**Change Directive
MSE/Gravity Retaining Wall
Wildcat Road Construction
May Day and Idaho Complex
La Plata County, Colorado**

June 3, 2014

PROJECT MEMORANDUM

To: George M.L. Robinson
From: J. Erich Rauber, P.E.
Date: June 1, 2014
Subject: MSE Wall Design Revisions

RETAINING WALL PROFILE PLAN
SCALE 3/16"=1'-0"

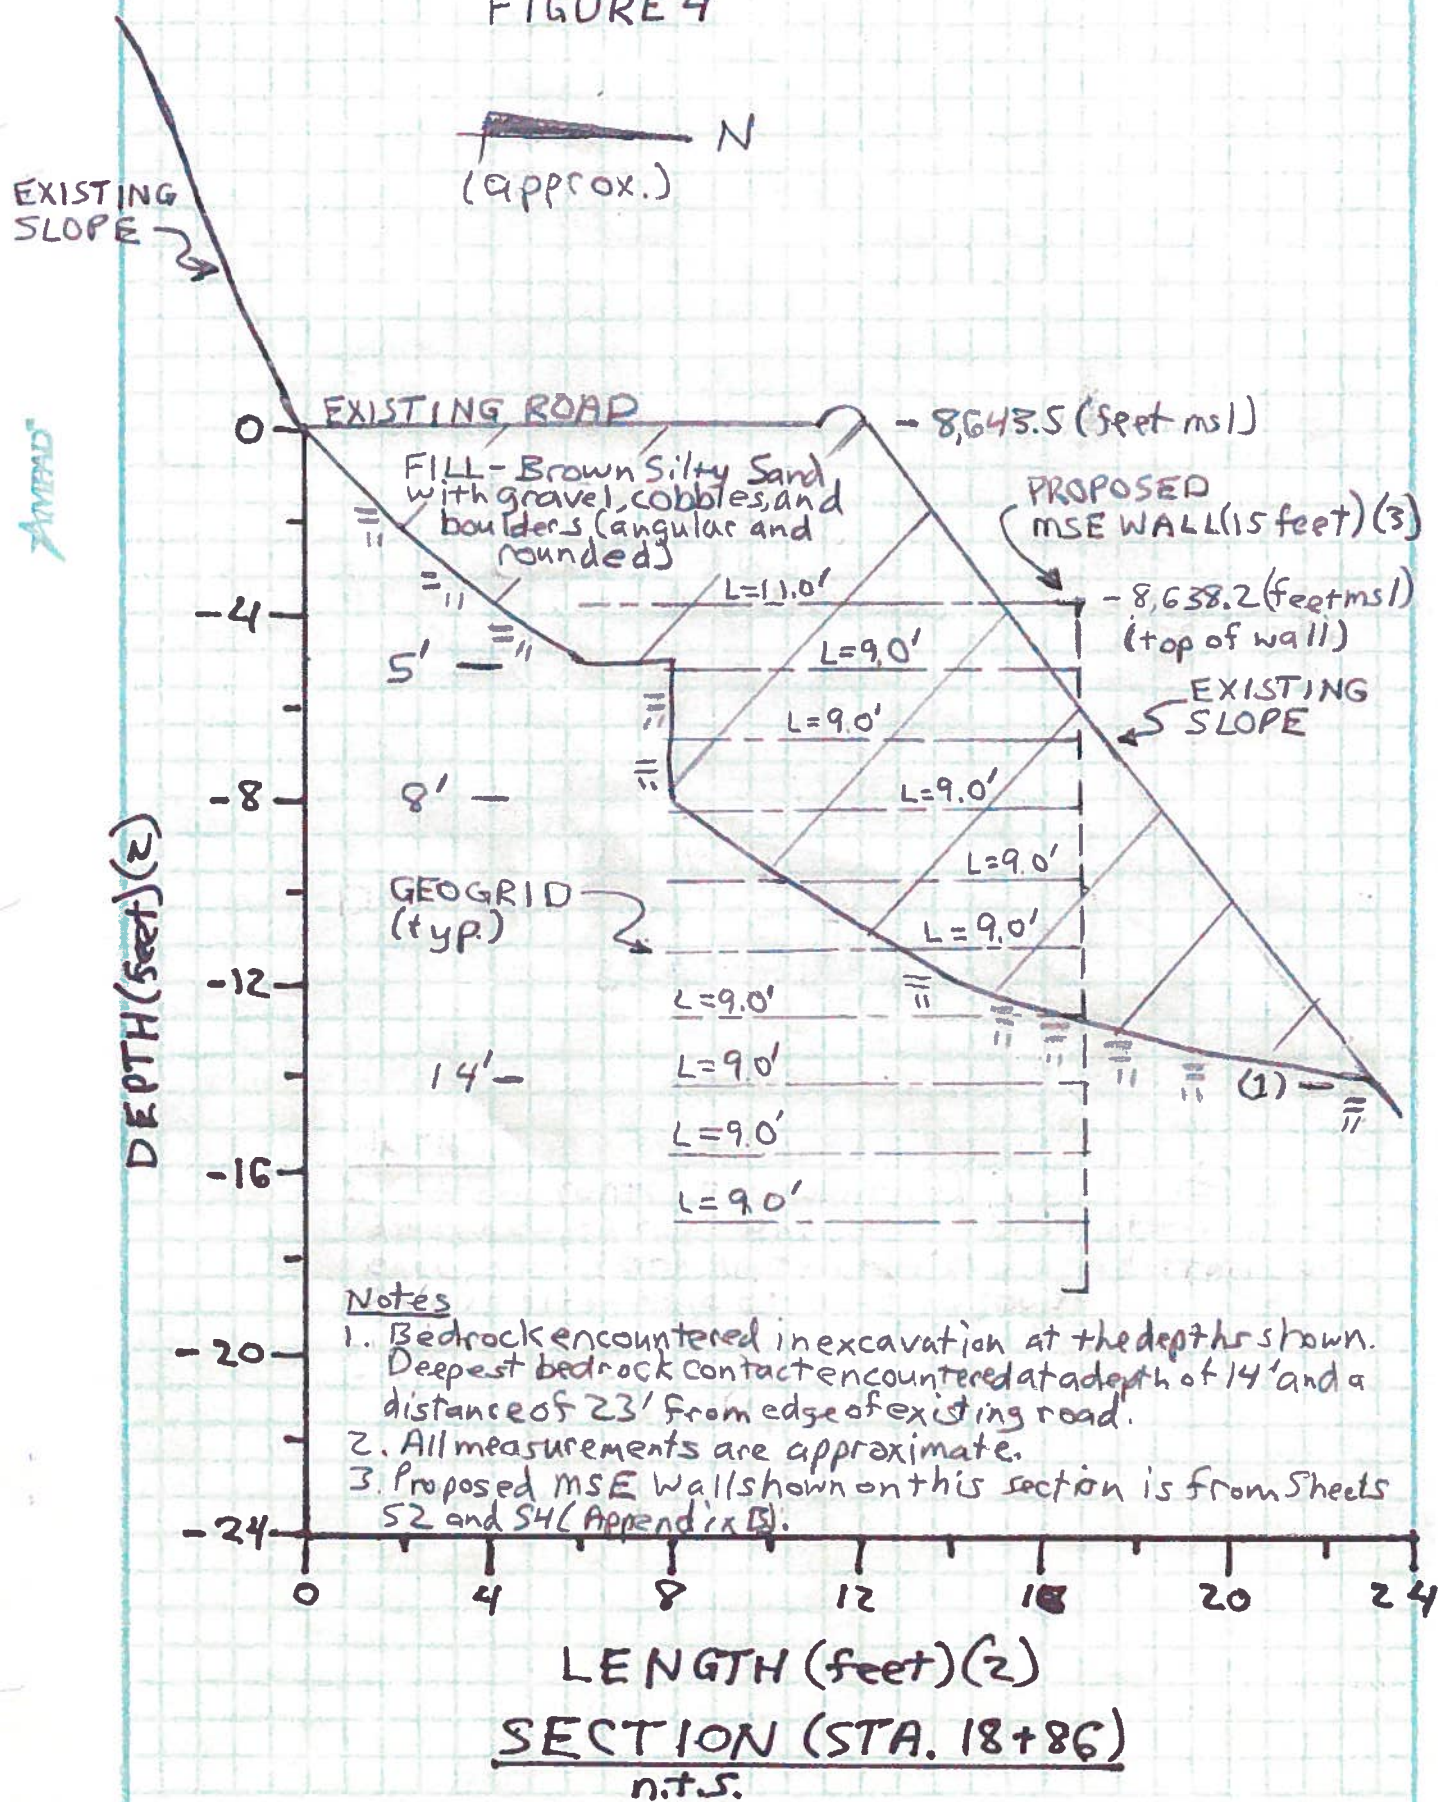
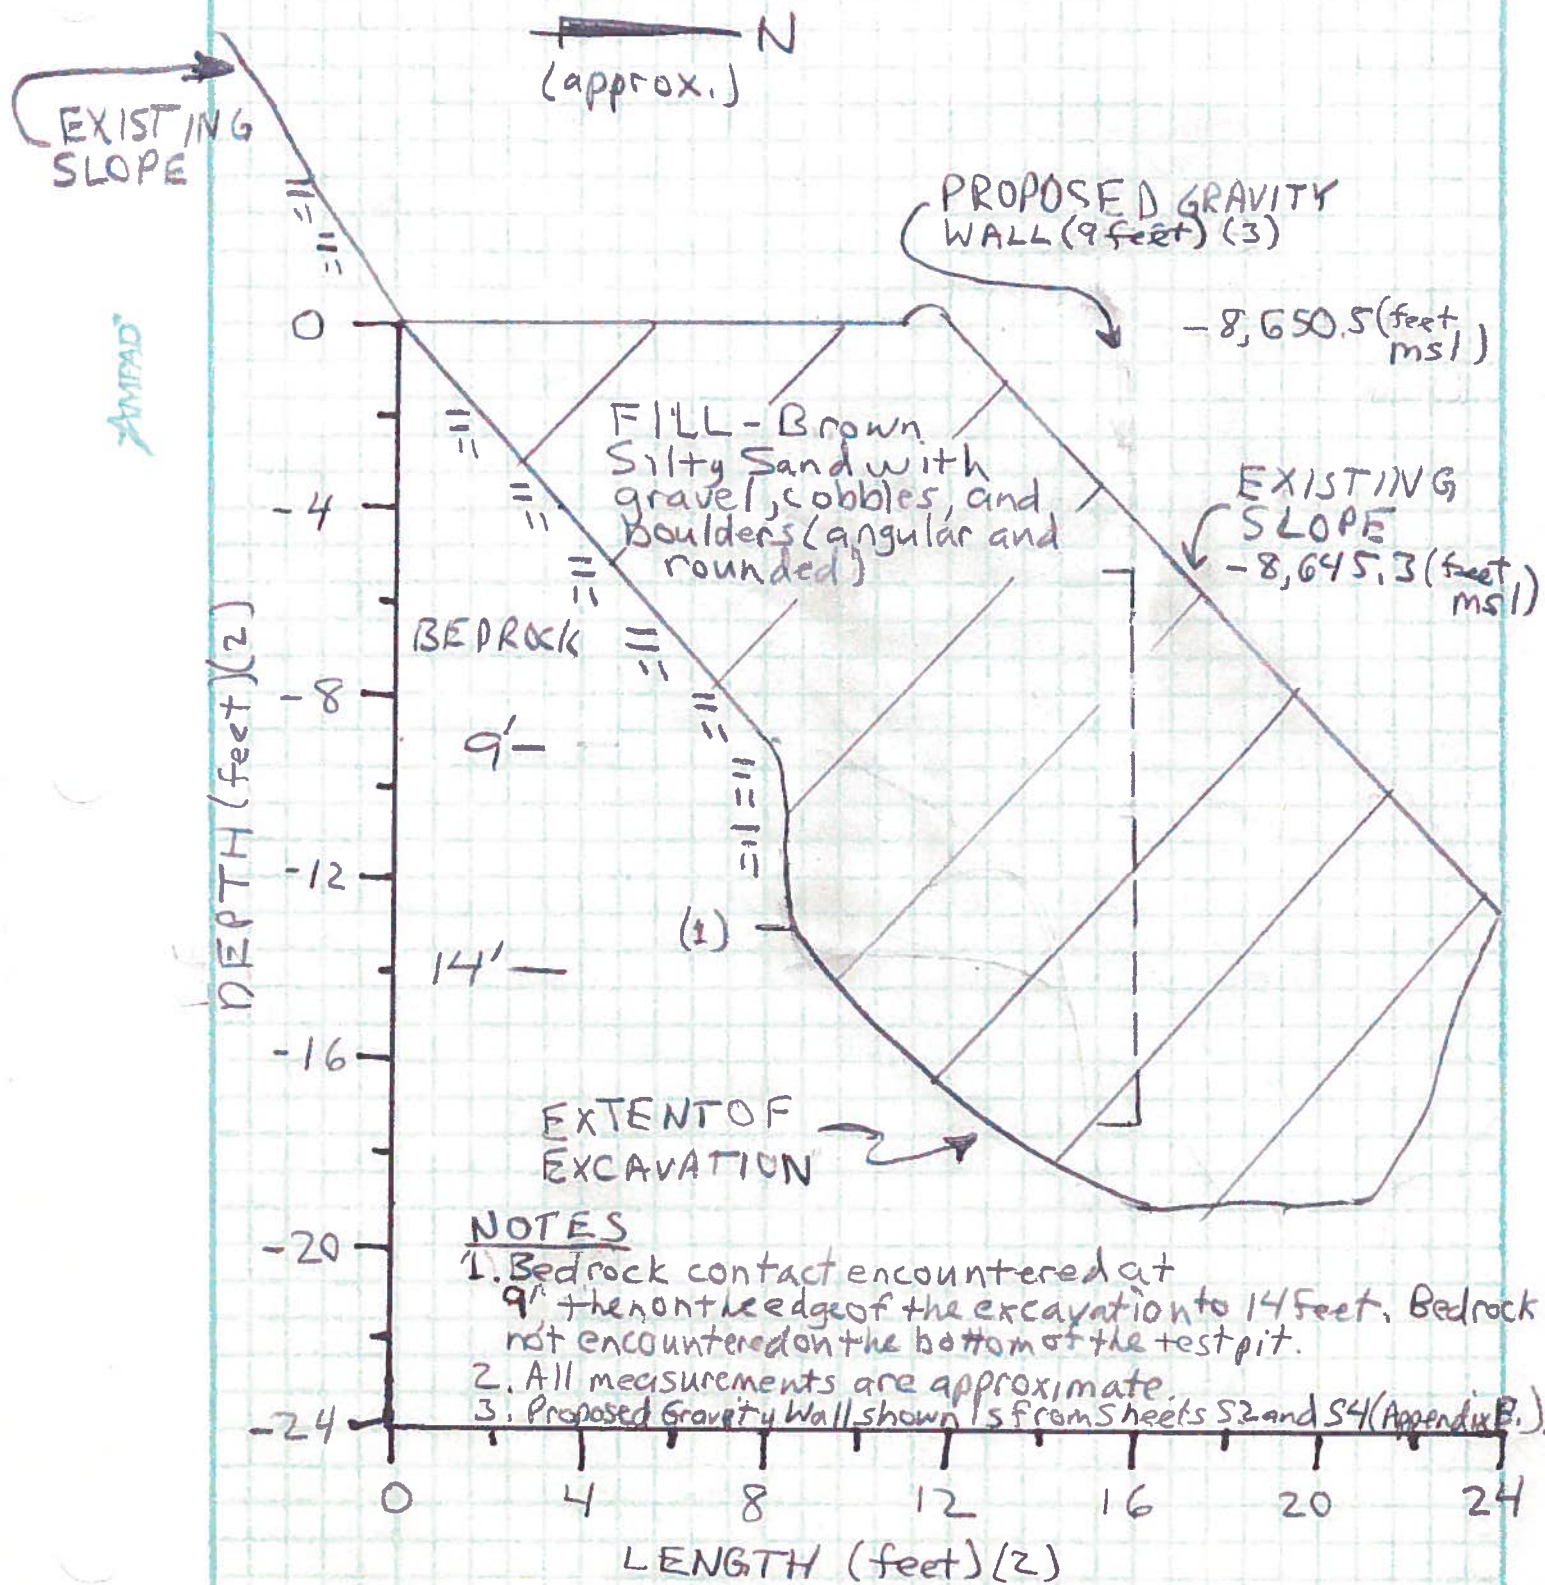
1. The MSE/Gravity Retaining Wall will require the addition of approximately 200 to 230 square feet of MSE/gravity wall block (35 to 40 blocks).
2. The wall section above the gravity wall between Stations 19+12 and 19+00 will transition to a MSE wall starting at the fifth course of block. Geogrid lengths will be as described on the attached memorandum.

3. The MSE wall between Stations 19+00 and 18+49 will increase as necessary to meet the proposed finish road grade. The MSE wall in this section will be constructed in accordance with Section 1 on Sheet S4 and the instructions included on the attached memorandum.

4. The transition between gravity wall and MSE wall currently shown on Sheets S1 and S2 at Station 18+49 will move to Station 18+41 to accommodate the estimated increased retaining wall height from 6 blocks (9 feet) to 8 blocks (12 feet) between these stations. The MSE wall in this section will be constructed in accordance with Section 1 on Sheet S4.

5. The gravity wall section between Stations 18+41 and 17+88 will be increased in height as necessary to meet the proposed finish road grades.

MSE BLOCKS = 52 Full

MSE BLOCKS = 10

RAV. BLOCKS = -10

ADDITIONAL MSE BLOCK = 62

FIGURE 5

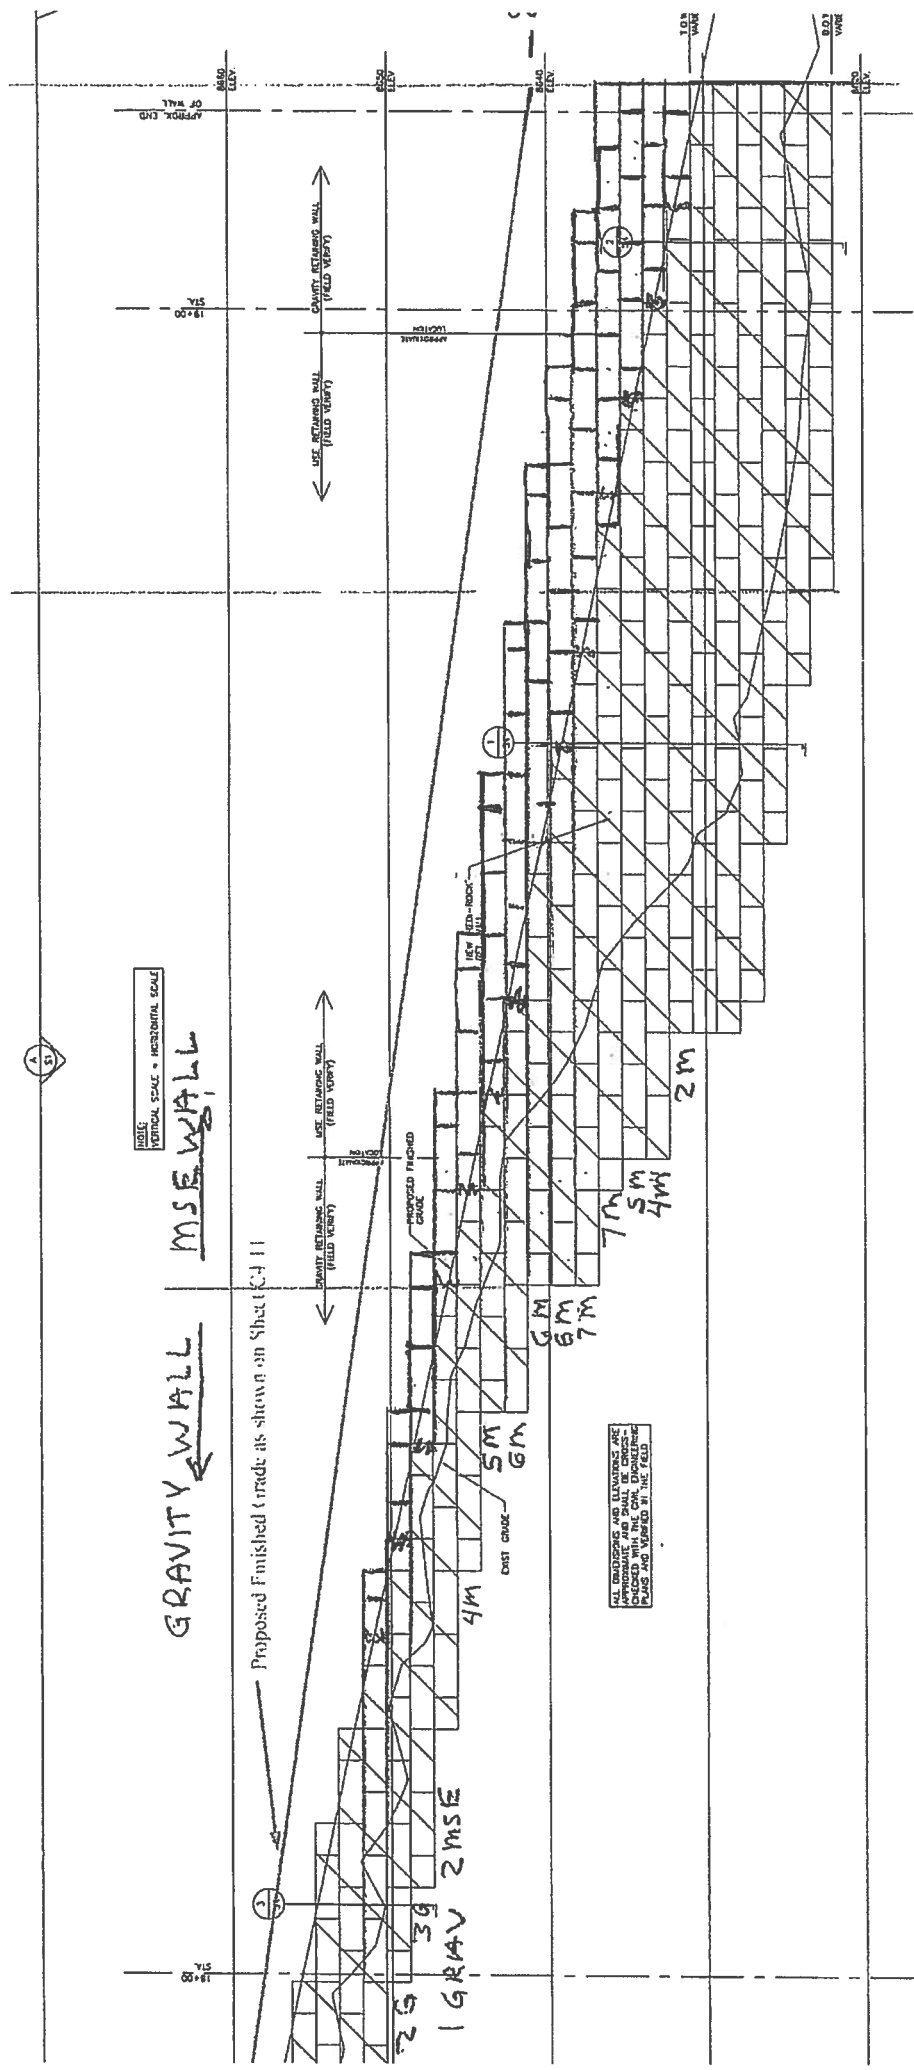
1. Bedrock contact encountered at 9' then on the edge of the excavation to 14 feet. Bedrock not encountered on the bottom of the test pit.
2. All measurements are approximate.
3. Proposed Gravity Wall shown is from Sheets S2 and S4 (Appendix B.).

1. Extend the wall height by constructing an MSE wall the from the current 7.5 foot height up to the planned 18 foot height. Use Mirafi 5XT mats. The upper mat should be at least 13 feet long, the next mat down should be at least 11 feet long, with 10 long mats the rest of the way down at 18 inch intervals.
2. Construct an earthen embankment at least 3 feet high in front of the gravity wall to provide lateral support. The embankment should be placed, compacted, and constructed on the same material as that specified for MSE wall backfill.
3. Stresses in the wall will concentrate along at the top of the gravity wall and the new MSE wall above. The wall blocks at 9 feet must be able to resist a shear force of approximately 8 kips/foot of wall.
